Sierra Vista Acres Replat A

City Plan Commission — May 22, 2025 (REVISED)

SUMMARY OF RECOMMENDATION: Staff recommends **APPROVAL** of Sierra Vista Acres Replat A on a Resubdivision Combination basis. In addition, staff recommends **APPROVAL** of the applicant's exception request from the City Plan Commission:

EXISTING CROSS-SECTION:

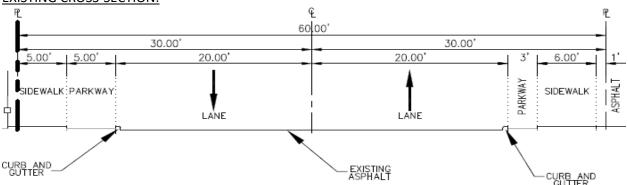
EXCEPTIONS, MODIFICATIONS, OR WAIVER REQUESTS: The applicant is requesting one (1) exception pursuant to El Paso City Code Section 19.10.050 (A)(1)(a) - (Roadway participation policies – Improvement of Roads and Utilities Within and or Abutting the Subdivision) of the applicable code. The exception includes the following:

1. To waive the dedication of one-foot (1') of additional right-of-way along Tetons Dr.

EVALUATION OF EXCEPTION REQUEST: The exception requests to waive right-of-way improvements meets the following criteria under El Paso City Code 19.10.050 (A)(1)(a) – (Roadway Participation Policies – Improvement of Roads and Utilities Within and or Abutting the Subdivision). The section reads the following:

a: Fifty per cent of the lots within a quarter mile of the proposed development have already been developed and the existing street improvements are in character with the neighborhood.

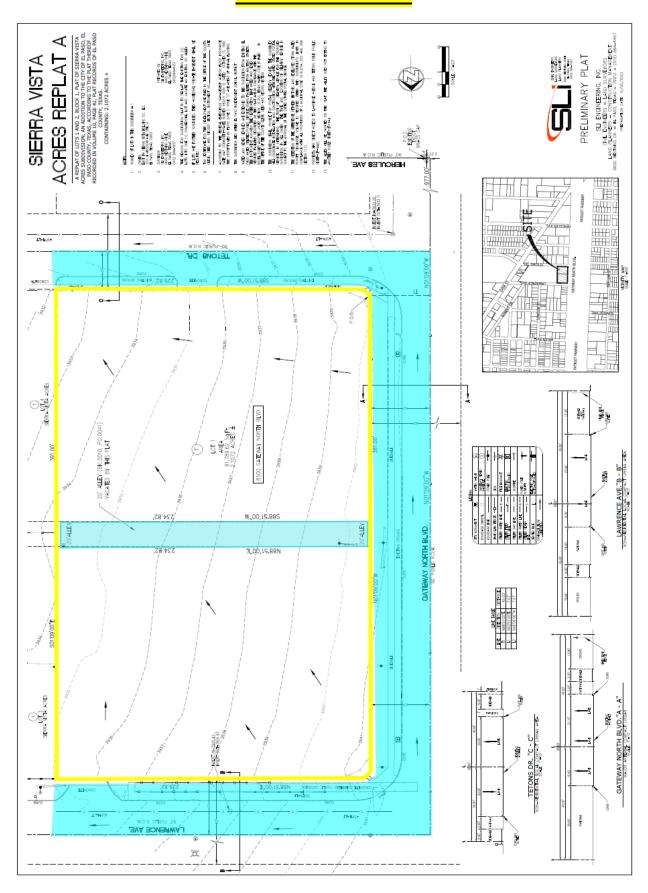
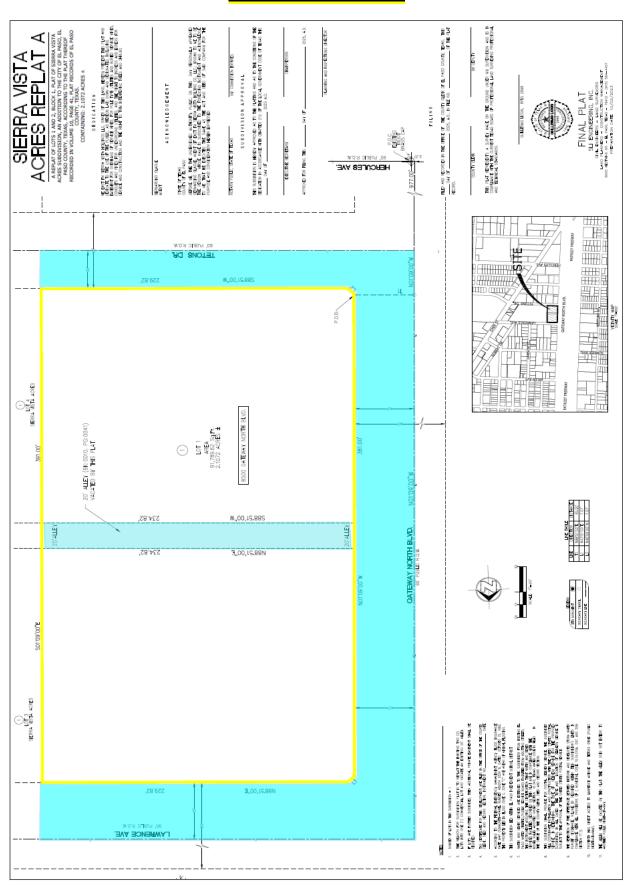
- 1. TXDOT review and approval are required of the proposed subdivision for drainage and access requirements, at the time of grading permit. No storm-water is allowed into TXDOT R.O.W.

- 2. Provide print-out of the mathematical closure of the exterior boundary of the subdivision indicating the error of closure.
- 3. Add general note to both the preliminary and final plat sheets: "The retention of all storm-water runoff discharge volume is required within this subdivision's limits in compliance with all provisions of (Muni-Code 19.19.010A, SDM, and DDM Section 11.1)."

- 4. Provide water flow into on-site ponding with arrows. Show existing and proposed drainage flow patterns on the preliminary plat. Identify the discharge location for all stormwater runoff. Approximate location of areas subject to inundation or stormwater overflow, and direction of flow of all watercourses.

- 5. Provide and label On-site ponding notes on Preliminary and Final plat.
- 6. The proposed ponding areas for subdivision shall have enough capacity to hold the developed runoff for a designated 100-yr. storm event, provide drainage calculations.

- 7. Provide a 6ft rock-wall from high side along the entire length adjacent to separate zoning C3C from zoning A2, at the time of grading permit (20.16.020 Mandatory walls. -A4).

- 8. Provide and label private drainage easement in case needed.

Please add a 10' wide easement along all lot lines of the property, we have existing lines throughout the property.
